Jericho Wind, Inc.

## **Revision to the Water Assessment and Water Body Report – Jericho Wind Energy Centre**

60301207

September, 2013

Figure 2-1

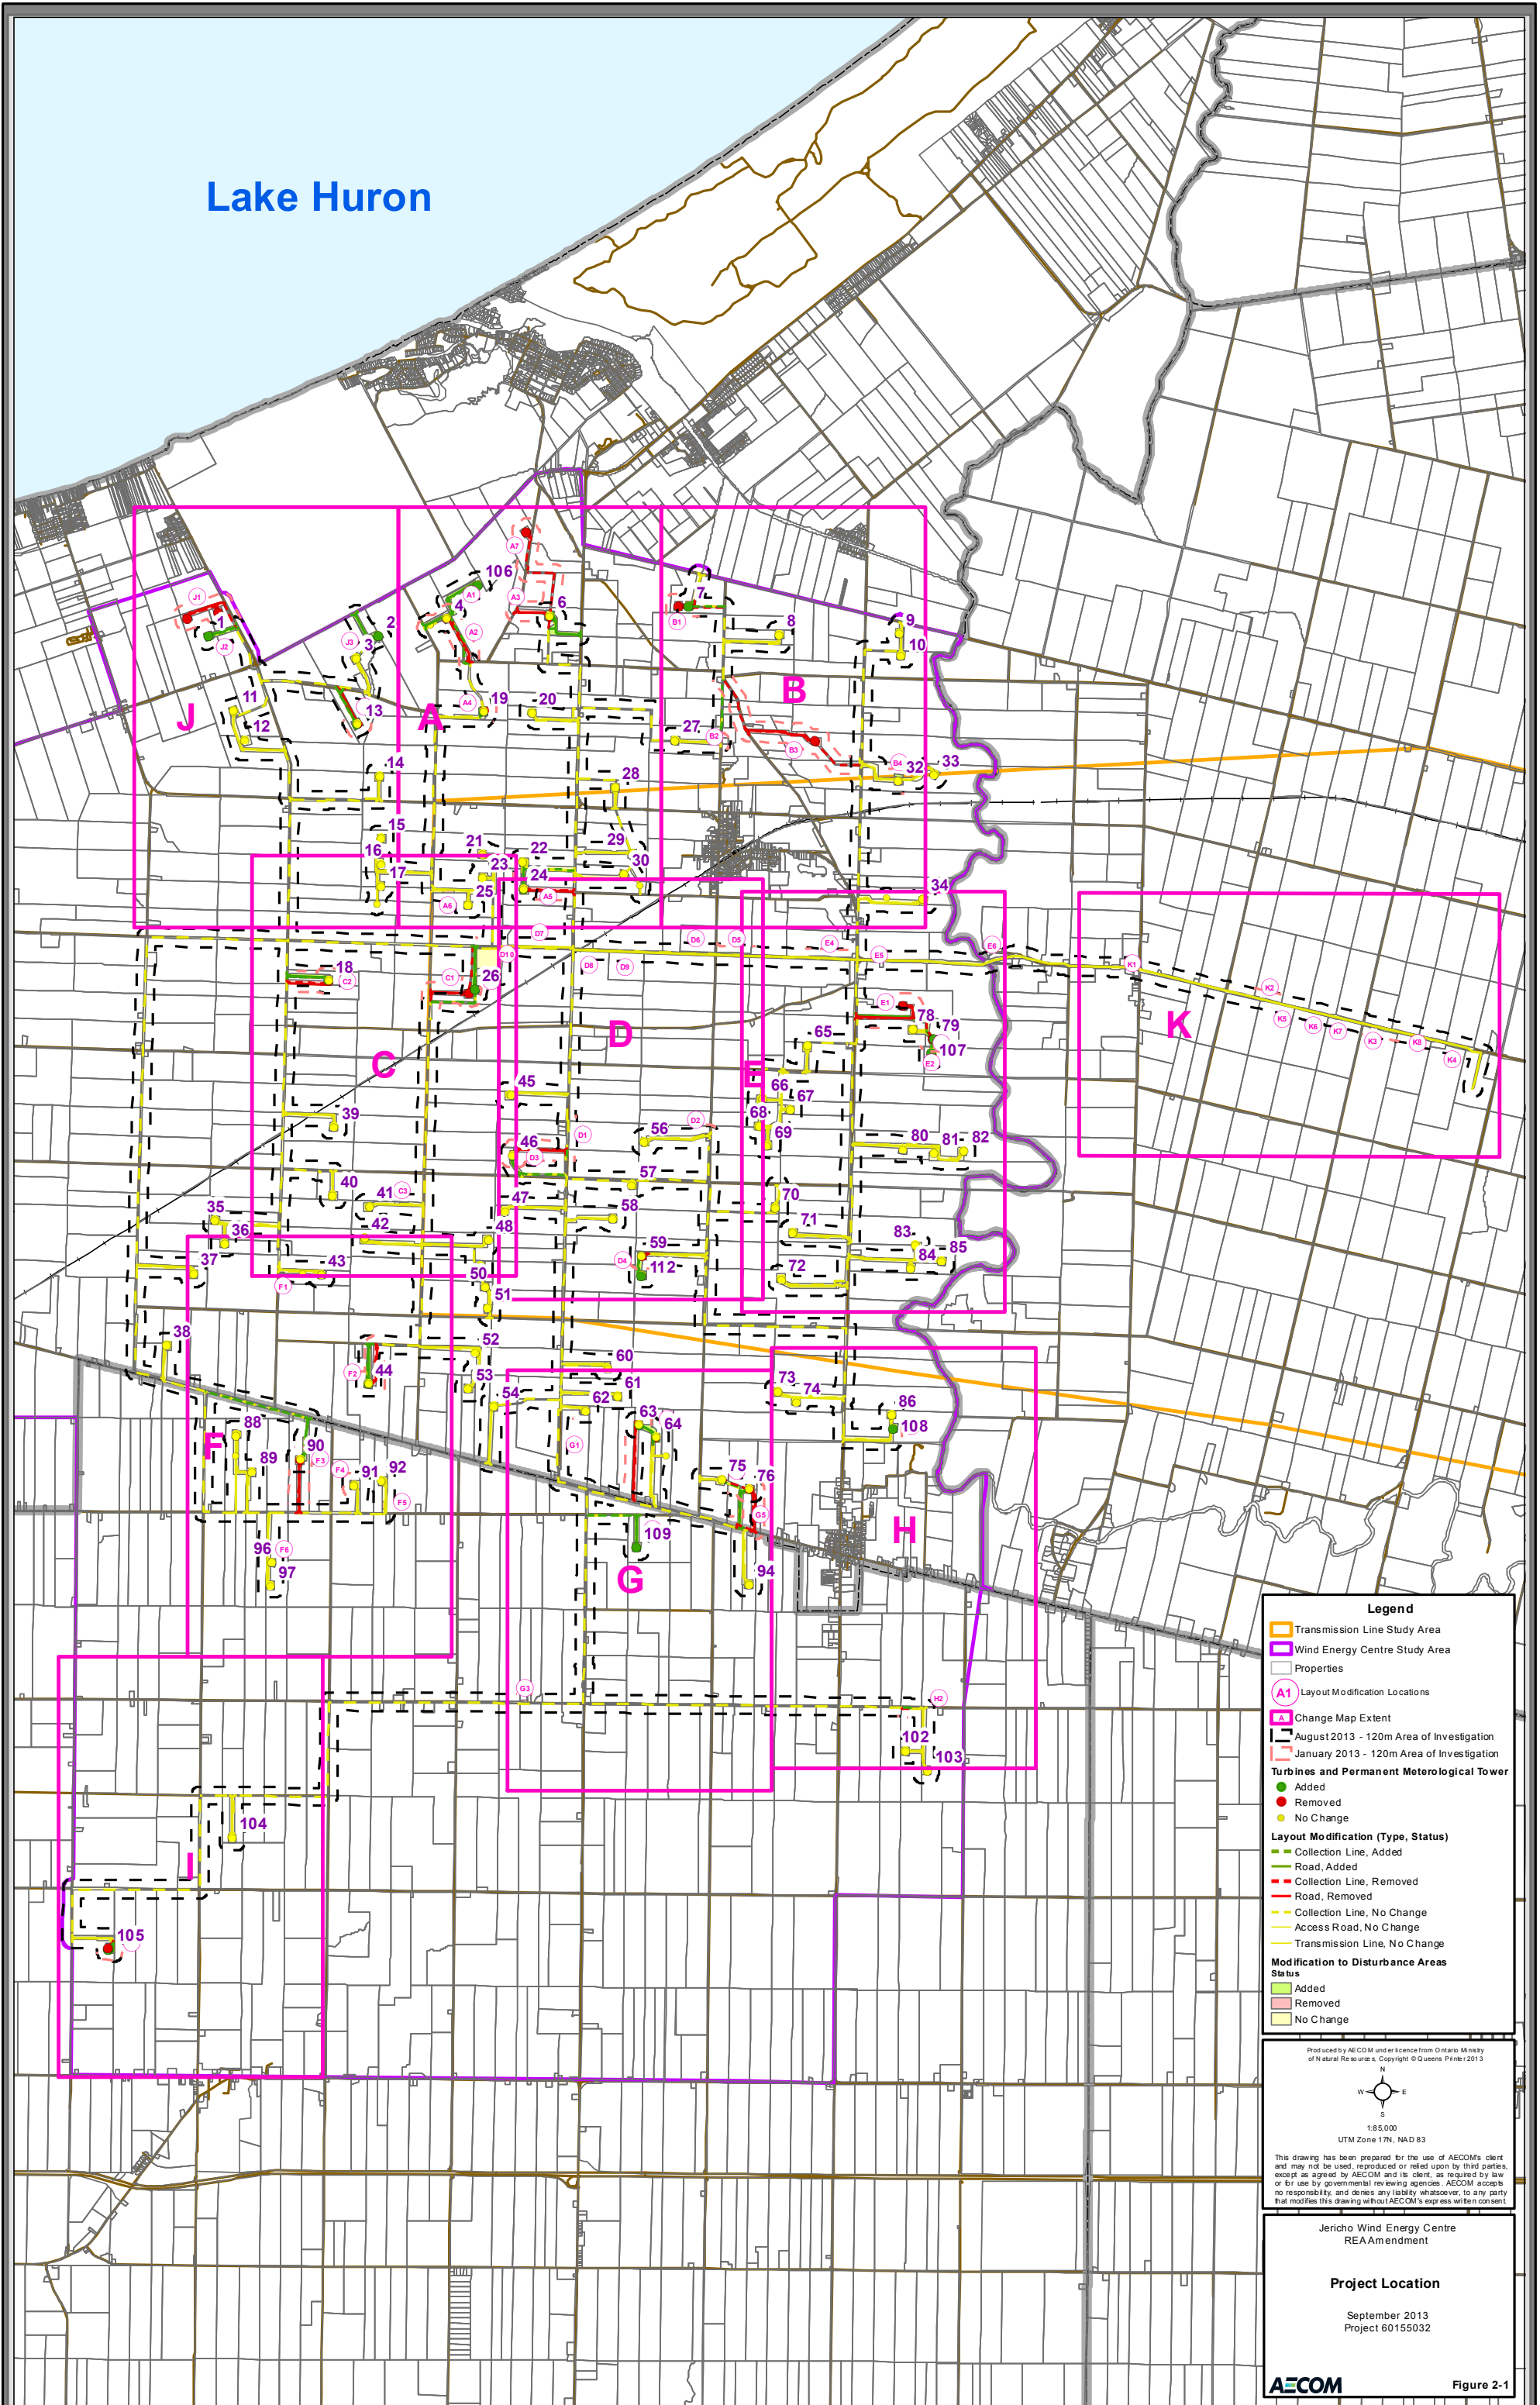
Label on Figure 2-1	Proposed Modification	Rationale for Proposed Modification	New Potential Environmental Effects <i>(related to Water Bodies)</i>	New Mitigation Measures <i>(related to Water Bodies)<sup>1</sup></i>
A1	Addition of Turbine 106 and associated access road and collection line, extending northeast from Turbine 4.	Infrastructure or construction disturbance area added or changed to optimize project design/ constructability.	<p>Water body present within 120 m buffer of turbine and infrastructure (Feature ID R4.16-D).</p> <p><b>Turbine</b></p> <ul style="list-style-type: none"> <li>• Increase to surface water temperature from reduced groundwater contribution if dewatering activities are required for excavation of turbine foundations.</li> <li>• Increase to streamflows in watercourses that receive temporary groundwater dewatering discharge (if required). Groundwater discharge has potential to cause streambed and/or bank erosion and downstream sedimentation if not managed properly.</li> <li>• Increased erosion, sedimentation and turbidity in watercourse from clearing and grubbing on adjacent lands for construction of turbine, pad and turnaround area.</li> <li>• Soil compaction, which may result in hardening of surfaces and increased runoff into watercourses.</li> <li>• Release / discharge of runoff from the construction area, which has the potential to transport sediment and nutrients into the watercourse.</li> <li>• Soil/water contamination by oils, grease and other materials from accidental spills and release of contaminants from construction equipment.</li> <li>• Increase in impervious surfaces from presence of turbine foundation, resulting in increased water temperatures, increased surface runoff and stream peak flows, and reduced infiltration, base flows and upwelling.</li> </ul> <p><b>Access Road</b></p> <ul style="list-style-type: none"> <li>• Increased erosion, sedimentation and turbidity from clearing and grubbing for construction of access roads.</li> <li>• Soil/water contamination by oils, grease and other materials from construction equipment.</li> <li>• Release / discharge of runoff from the construction area, which has the potential to transport sediment and nutrients into the watercourse.</li> <li>• Reduction of streamflow due to the withdrawal of surface water for construction activities such as dust suppression, equipment washing and land reclamation (e.g., hydroseeding).</li> <li>• Increase in impervious surfaces from presence of access road, resulting in increased water temperatures, increased surface runoff and stream peak flows, and reduced infiltration, base flows and upwelling.</li> </ul> <p><b>Collection Line</b></p> <ul style="list-style-type: none"> <li>• Soil / water contamination by oils, gasoline, grease and other materials from accidental spills and release of contaminants from equipment.</li> <li>• Release / discharge of runoff from the construction area, which has the potential to transport sediment and nutrients into the watercourse.</li> </ul>	<p><b>Turbine</b></p> <ul style="list-style-type: none"> <li>• Timing windows</li> <li>• Erosion and sediment control</li> <li>• Grading and excavation</li> <li>• Material stockpiling and handling</li> </ul> <p><b>Access Road</b></p> <ul style="list-style-type: none"> <li>• Timing Windows</li> <li>• Erosion and sediment control</li> <li>• Grading and excavation</li> <li>• Equipment use</li> <li>• Material stockpiling and handling</li> </ul> <p><b>Collection Line</b></p> <ul style="list-style-type: none"> <li>• Equipment use</li> <li>• Erosion and sediment control</li> </ul>

A2	Relocation of access road to Turbine 4 to travel northeast from Jericho Road, and relocation of collection line to Turbine 4 near Kennedy Line.	Construction disturbance area modified to reduce or eliminate impacts to archaeological resources.	No new effects identified.	n/a
A3	Relocation of access road and collection line to Turbine 6 to travel west from Northville Road and then north to Turbine 6; relocation of Turbine 6 construction disturbance area to the north.	Construction disturbance area modified to reduce or eliminate impacts to archaeological resources.	None – no water bodies identified in the new 120 m infrastructure buffer.	n/a
A4	Relocation of Turbine 19 construction disturbance area 19 m to the southwest and addition of access road construction disturbance area near Jericho Road.	Construction disturbance area modified to reduce or eliminate impacts to archaeological resources.	No new effects identified.	n/a

A5	Removal of access road and collection line to Turbine 24, addition of access road disturbance area between Turbine 22 and Turbine 24 and relocation of collection line to the access road disturbance area for Turbine 22.	Infrastructure or construction disturbance area added or changed to optimize project design/ constructability.	<p>2 road crossings on the water body instead of 1(Feature ID R4.33-B). The potential environmental effects on the water body present in 120 m buffer and new access road crossing are listed below.</p> <p><b>Access Road</b></p> <ul style="list-style-type: none"> <li>• Obstruction of lateral flows in watercourses from water crossings.</li> <li>• Temporary disruption of substrates/habitat at locations where in-water work is required (culvert installations).</li> <li>• Degradation of fish habitat from culvert installation.</li> <li>• Increased erosion, sedimentation and turbidity from clearing and grubbing for construction of access roads.</li> <li>• Soil/water contamination by oils, grease and other materials from construction equipment.</li> <li>• Release / discharge of runoff from the construction area, which has the potential to transport sediment and nutrients into the watercourse.</li> <li>• Reduction of streamflow due to the withdrawal of surface water for construction activities such as dust suppression, equipment washing and land reclamation (e.g., hydroseeding).</li> <li>• Increase in impervious surfaces from presence of access road, resulting in increased water temperatures, increased surface runoff and stream peak flows, and reduced infiltration, base flows and upwelling.</li> <li>• Soil/water contamination by oils, grease and other materials from maintenance activities.</li> <li>• Obstruction of lateral flows in watercourses and other water bodies due to design of culverts and debris build-up at water crossings.</li> </ul>	<p><b>Access Road</b></p> <ul style="list-style-type: none"> <li>• Culvert Design</li> <li>• Isolated crossing</li> <li>• Timing Windows</li> <li>• Erosion and sediment control</li> <li>• Grading and excavation</li> <li>• Equipment use</li> <li>• Material stockpiling and handling</li> <li>• Water quality</li> <li>• Water management</li> <li>• Rehabilitation</li> </ul>

B3	Removal of Turbine 31 and associated access road and collection line.	Turbine and associated infrastructure removed.	None – removal of turbine and infrastructure.	
B4	Addition of Turbine 32 construction disturbance area 34 m to the north and removal of the southeast portion of construction disturbance area.	Construction disturbance area modified to reduce or eliminate impacts to archaeological resources.	None – no water bodies identified in the new 120 m infrastructure buffer.	
C1	Relocation of Turbine 26 and associated construction disturbance area 101 m east. Access road relocated to travel north through the substation construction disturbance area and collection line relocated to the southern property boundary; and addition of construction disturbance area in Thompson Line right-of-way.	Infrastructure or construction disturbance area added or changed to optimize project design/ constructability.	Water body present in 120 m buffer of access road, and 120 m buffer of collection line and collection line crossing (Feature ID R4.16-A). <b>Access Road</b> <ul style="list-style-type: none"> <li>• Increased erosion, sedimentation and turbidity from clearing and grubbing for construction of access road.</li> <li>• Soil/water contamination by oils, grease and other materials from construction equipment.</li> <li>• Release / discharge of runoff from the construction area, which has the potential to transport sediment and nutrients into the watercourse.</li> <li>• Reduction of streamflow due to the withdrawal of surface water for construction activities such as dust suppression, equipment washing and land reclamation (e.g., hydroseeding).</li> <li>• Increase in impervious surfaces from presence of access road, resulting in increased water temperatures, increased surface runoff and stream peak flows, and reduced infiltration, base flows and upwelling.</li> <li>• Soil/water contamination by oils, grease and other materials from maintenance activities.</li> </ul> <b>Collection Line</b> <ul style="list-style-type: none"> <li>• Release of pressurized drilling fluids into watercourses from fractures in substrate (also known as a ‘frac-out’).</li> <li>• Change to groundwater flow patterns which may affect groundwater discharge to watercourses.</li> <li>• Increase in erosion and sedimentation from the entry and exit drill holes required for the directional drilling activities. This will require clearing and grubbing of the land and removal of substrates from the drill hole.</li> <li>• Soil / water contamination by oils, gasoline, grease and other materials from accidental spills and release of contaminants from equipment.</li> <li>• Release / discharge of runoff from the construction area, which has the potential to transport sediment and nutrients into the watercourse.</li> </ul>	<b>Access Road</b> <ul style="list-style-type: none"> <li>• Timing windows</li> <li>• Erosion and sediment control</li> <li>• Grading and excavation</li> <li>• Equipment use</li> <li>• Material stockpiling and handling</li> <li>• Water quality</li> <li>• Water management</li> </ul> <b>Collection Line</b> <ul style="list-style-type: none"> <li>• Directional drilling</li> <li>• Water quality</li> <li>• Water management</li> <li>• Erosion and sediment control</li> </ul>

C2	Relocation of access road to Turbine 18 31 m to the north.	Construction disturbance area modified to reduce or eliminate impacts to archaeological resources.	None – no water bodies identified in the new 120 m infrastructure buffer.	n/a
C3	Addition of construction disturbance area for access road and collection line to Turbine 41.	Infrastructure or construction disturbance area added or changed to optimize project design/ constructability.	No new effects identified.	n/a
C4	Addition of a spare 170 mVA transformer (XMR) to be stored within the existing footprint of the Jericho substation.	Infrastructure or construction disturbance area added or changed to optimize project design/ constructability.	No new effects identified.	n/a
D1	Addition of construction disturbance area in the Northville Road right-of-way in two locations for collection line between Turbines 45 and 46.	New infrastructure or construction disturbance area added or changed to optimize project design/ constructability.	None – no water bodies identified in the new 120 m infrastructure buffer.

D2	Removal of a portion of construction disturbance area for access road and collection line to Turbine 56.	Construction disturbance area modified to reduce or eliminate impacts to archaeological resources.	No new effects identified.	n/a

D4	Addition of Turbine 112 and associated access road and collection line, extending south from Turbine 59.	New infrastructure or construction disturbance area added or changed to optimize project design/ constructability.	None – no water bodies identified in the new 120 m infrastructure buffer.	n/a
D5	Addition of construction disturbance area on private property to the north of Thompson Line to allow for installation of collection line and/or transmission line.	New infrastructure or construction disturbance area added or changed to optimize project design/ constructability.	None – no water bodies identified in the new 120 m infrastructure buffer.	n/a
D6	Addition of transmission line construction disturbance area on private property to allow for transmission line installation either in the Thomson Line right-of-way or on private property, within the disturbance area proposed to host collection line.	New infrastructure or construction disturbance area added or changed to optimize project design/ constructability.	No new effects identified.	n/a

D7	Addition of collection line disturbance area on private property to allow for collection line installation either in the Thomson Line right-of-way or on private property, within the disturbance area proposed to host the transmission line.	New infrastructure or construction disturbance area added or changed to optimize project design/ constructability.	No new effects identified.	n/a
D8	Addition of collection line disturbance area on private property to allow for collection line installation either in the Thomson Line right-of-way or on private property, within the disturbance area proposed to host the transmission line.	New infrastructure or construction disturbance area added or changed to optimize project design/ constructability.	None – no water bodies identified in the new 120 m infrastructure buffer.	n/a
D9	Addition of collection line disturbance area on private property to allow for collection line installation either in the Thomson Line right-of-way or on private property, within the disturbance area proposed to host the transmission line.	New infrastructure or construction disturbance area added or changed to optimize project design/ constructability.	No new effects identified.	n/a

D10	Relocation of transmission line construction disturbance area within natural areas located in the Thompson Line right-of-way.	Infrastructure or construction disturbance area added or changed to optimize project design/ constructability.	No new effects identified.	n/a
E1	Removal of Turbine 77 and associated access road and collection line / Removal and addition of portions of construction disturbance area for access road and collection line to Turbines 78, 79 and 107.	Turbine and associated infrastructure removed / Construction disturbance area modified to reduce or eliminate impacts to archaeological resources.	No new effects identified.	n/a
E2	Addition of Turbine 107 and associated access road and collection line, extending south from Turbine 79.	Infrastructure or construction disturbance area added or changed to optimize project design/ constructability.	None – no water bodies identified in the new 120 m infrastructure buffer.	n/a

E3	Relocation of Turbine 79 23 m to the east, within existing turbine construction disturbance area.	Construction disturbance area modified to reduce or eliminate impacts to archaeological resources.	No new effects identified.	n/a
E4	Addition of construction disturbance area on private property to the north of Thompson Line to allow for installation of collection line and/or transmission line.	Infrastructure or construction disturbance area added or changed to optimize project design/ constructability.	None – no water bodies identified in the new 120 m infrastructure buffer.	n/a
E5	Relocation of transmission line construction disturbance area within natural areas located in the Thompson Line road right-of-way.	Infrastructure or construction disturbance area added or changed to optimize project design/ constructability.	None – no water bodies identified in the new 120 m infrastructure buffer.	n/a

E6	Relocation of transmission line construction disturbance area within natural areas located in the Thompson Line/Elginfield Road right-of-way.	Infrastructure or construction disturbance area added or changed to optimize project design/ constructability.	None – no water bodies identified in the new 120 m infrastructure buffer.	n/a

F4	Addition of Turbine 91 construction disturbance area 17 m to the west.	Infrastructure or construction disturbance area added or changed to optimize project design/ constructability.	No new effects identified.	n/a
F5	Removal of a portion of construction disturbance area for access road and collection line to Turbine 92.	Construction disturbance area modified to reduce or eliminate impacts to archaeological resources.	No new effects identified.	n/a
F6	Removal of a portion of construction disturbance area for access road and collection line to Turbines 96 and 97.	Construction disturbance area modified to reduce or eliminate impacts to archaeological resources.	No new effects identified.	n/a
G1	Addition of Turbine 62 construction disturbance area to the west and addition of collection line disturbance area in two locations in the Northville Road right-of-way.	Infrastructure or construction disturbance area added or changed to optimize project design/ constructability.	No new effects identified.	n/a

G2	Removal of the road and collection line to Turbine 63 and addition of road and collection line, extending west from Turbine 64 to Turbine 63.	Construction disturbance area modified to reduce or eliminate impacts to archaeological resources.	None – no water bodies identified in the new 120 m infrastructure buffer.	n/a
G3	Removal of collection line construction disturbance area north of Birnam Line.	Infrastructure or construction disturbance area added or changed to optimize project design/ constructability.	None – no water bodies identified in the new 120 m infrastructure buffer.	n/a
G4	Relocation of collection line between Turbines 76 and 75 20 m to the south.	Construction disturbance area modified to reduce or eliminate impacts to archaeological resources.	None – no water bodies identified in the new 120 m infrastructure buffer.	
G5	Relocation of Turbine 76 access road and collection line 134 m to the west.	Construction disturbance area modified to reduce or eliminate impacts to archaeological resources.	No new effects identified. Removal of water body from 120 m infrastructure buffer however, 2 ponds remain in 120 m buffer.

G6	Addition of Turbine 109 and associated construction disturbance area, access road and collection line; addition of collection line in Hickory Creek Line right-of-way.	Infrastructure or construction disturbance area added or changed to optimize project design/ constructability.	Water body present within 120 m buffer of turbine (Feature ID 9.29-F). <b>Turbine</b> <ul style="list-style-type: none"> <li>• Increase to surface water temperature from reduced groundwater contribution if dewatering activities are required for excavation of turbine foundations.</li> <li>• Increase to streamflows in watercourses that receive temporary groundwater dewatering discharge (if required). Groundwater discharge has potential to cause streambed and/or bank erosion and downstream sedimentation if not managed properly.</li> <li>• Increased erosion, sedimentation and turbidity in watercourse from clearing and grubbing on adjacent lands for construction of turbine, pad and turnaround area.</li> <li>• Soil compaction, which may result in hardening of surfaces and increased runoff into watercourses.</li> <li>• Release / discharge of runoff from the construction area, which has the potential to transport sediment and nutrients into the watercourse.</li> <li>• Soil/water contamination by oils, grease and other materials from accidental spills and release of contaminants from construction equipment.</li> <li>• Increase in impervious surfaces from presence of turbine foundation, resulting in increased water temperatures, increased surface runoff and stream peak flows, and reduced infiltration, base flows and upwelling.</li> </ul>	<b>Turbine</b> <ul style="list-style-type: none"> <li>• Timing windows</li> <li>• Erosion and sediment control</li> <li>• Grading and excavation</li> <li>• Material stockpiling and handling</li> </ul>

H1	Addition of Turbine 108 and associated construction disturbance area.	Infrastructure or construction disturbance area added or changed to optimize project design/ constructability.	No new effects identified.	n/a
H2	Relocation of collection line from private property to Birnam Line right-of-way.	Construction disturbance area modified to reduce or eliminate impacts to archaeological resources.	None – no water bodies identified in the new 120 m infrastructure buffer.	n/a
I1	Relocation of Turbine 105 20 m to the south and addition of construction disturbance area.	Infrastructure or construction disturbance area added or changed to optimize project design/ constructability.	No new effects identified.	n/a
J1	Removal of Turbine 2 and associated access road and collection line.	Turbine and associated infrastructure removed	None – removal of turbine and infrastructure.	n/a

<b>J3</b>	Addition of Turbine 2 and associated construction disturbance area, access road and collection line.	Infrastructure or construction disturbance area added or changed to optimize project design/ constructability.	Water body present within 120 m buffer of turbine (Feature ID R4-J). <b>Turbine</b> <ul style="list-style-type: none"> <li>• Increase to surface water temperature from reduced groundwater contribution if dewatering activities are required for excavation of turbine foundations .</li> <li>• Increase to streamflows in watercourses that receive temporary groundwater dewatering discharge (if required). Groundwater discharge has potential to cause streambed and/or bank erosion and downstream sedimentation if not managed properly.</li> <li>• Increased erosion, sedimentation and turbidity in watercourse from clearing and grubbing on adjacent lands for construction of turbine, pad and turnaround area.</li> <li>• Soil compaction, which may result in hardening of surfaces and increased runoff into watercourses.</li> <li>• Release / discharge of runoff from the construction area, which has the potential to transport sediment and nutrients into the watercourse.</li> <li>• Soil/water contamination by oils, grease and other materials from accidental spills and release of contaminants from construction equipment.</li> <li>• Increase in impervious surfaces from presence of turbine foundation, resulting in increased water temperatures, increased surface runoff and stream peak flows, and reduced infiltration, base flows and upwelling.</li> </ul>	<b>Turbine</b> <ul style="list-style-type: none"> <li>• Timing windows</li> <li>• Erosion and sediment control</li> <li>• Grading and excavation</li> <li>• Material stockpiling and handling</li> </ul>

<b>J4</b>	Relocation of Turbine 13 construction disturbance area 14 m southwest.	Construction disturbance area modified to reduce or eliminate impacts to archaeological resources.	No new effects identified.	n/a
<b>K1</b>	Relocation of transmission line construction disturbance area within natural areas located in the Elginfield Road right-of-way.	New infrastructure or construction disturbance area added or changed to optimize project design/ constructability.	None – no water bodies identified in the new 120 m infrastructure buffer.	n/a
<b>K2</b>	Addition of transmission line of construction disturbance area on private property to the north of Elginfield Road, east of Pete Sebe Road.	New infrastructure or construction disturbance area added or changed to optimize project design/ constructability.	None – no water bodies identified in the new 120 m infrastructure buffer.	n/a
<b>K3</b>	Addition of transmission line construction disturbance area on private property to the south of Elginfield Road, east of Roddick Road.	New infrastructure or construction disturbance area added or changed to optimize project design/ constructability.	No new effects identified.	n/a

<b>K1</b>	Relocation of transmission line construction disturbance area within natural areas located in the Elginfield Road right-of-way.	Infrastructure or construction disturbance area added or changed to optimize project design/ constructability.	No new effects identified.	n/a
<b>K2</b>	Addition of transmission line of construction disturbance area on private property to the north of Elginfield Road, east of Pete Sebe Road.	Infrastructure or construction disturbance area added or changed to optimize project design/ constructability.	No new effects identified.	n/a
<b>K3</b>	Addition of transmission line construction disturbance area on private property to the south of Elginfield Road, east of Roddick Road.	Infrastructure or construction disturbance area added or changed to optimize project design/ constructability.	No new effects identified.	n/a
<b>K4</b>	Addition of transmission line construction disturbance area on private property to the south of Elginfield Road, west of Kerwood Road.	Infrastructure or construction disturbance area added or changed to optimize project design/ constructability.	No new effects identified.	n/a

<b>K5</b>	Relocation of transmission line construction disturbance area within natural areas located in the Elginfield Road right-of-way.	Infrastructure or construction disturbance area added or changed to optimize project design/ constructability.	No new effects identified.	n/a
